ATTACHMENT 2 TO AEP:NRC:08940

PROPOSED REVISED TECHNICAL SPECIFICATION PAGES

FIGURE 3.4-2

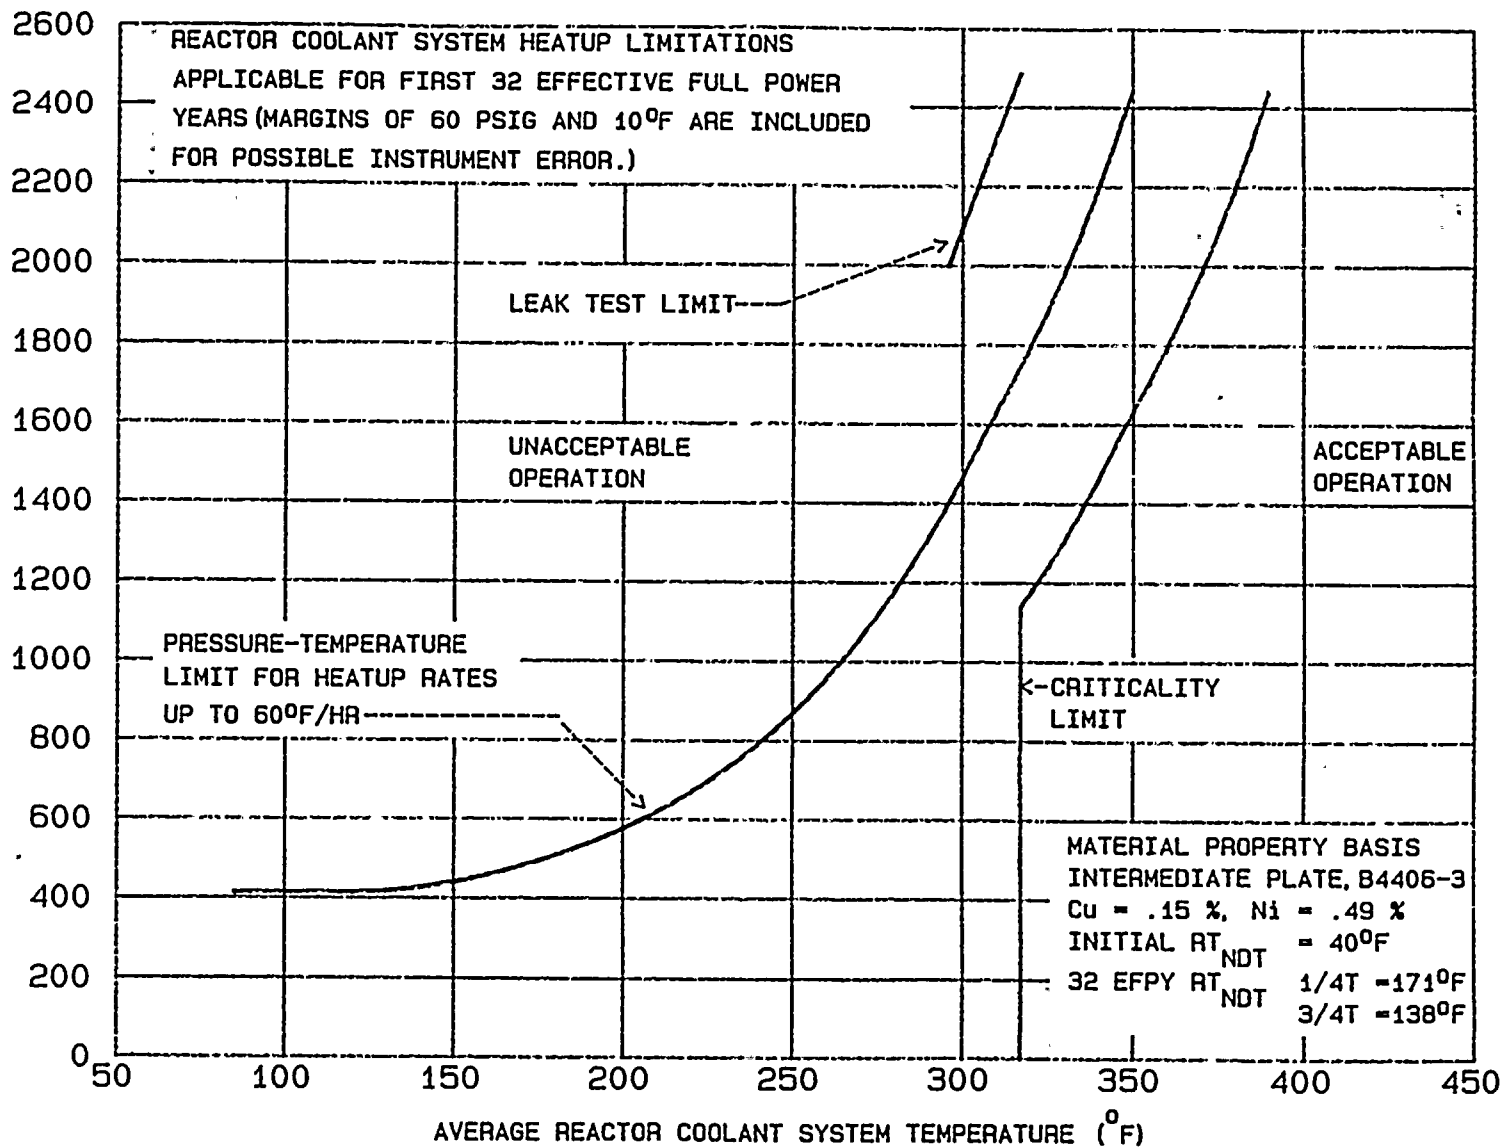
3.4.9.1 The Reactor Coolant System (except the pressurizer) temperature and pressure shall be limited in accordance with the limit lines shown on Figures 3.4-2 and 3.4-3 during heatup, cooldown, criticality, and inservice leak and hydrostatic testing with:

The heatup limit curve, Figure 3.4-2, is a composite curve which was prepared by determining the most conservative case, with either the inside or outside wall controlling, for any heatup rate up to 60°F per hour. The cooldown limit curves of Figure 3.4-3 are composite curves which were prepared based upon the same type analysis with the exception that the controlling location is always the inside wall where the cooldown thermal gradients tend to produce tensile stresses while producing compressive stresses at the outside wall. The heatup and cooldown curves were prepared based upon the most limiting value of the predicted adjusted reference temperature at the end of 32 EFPY.

The pressure-temperature limit lines shown on Figure 3.4-2 for reactor criticality and for inservice leak and hydrostatic testing have been provided to assure compliance with the minimum temperature requirements of Appendix G to 10 CFR 50.
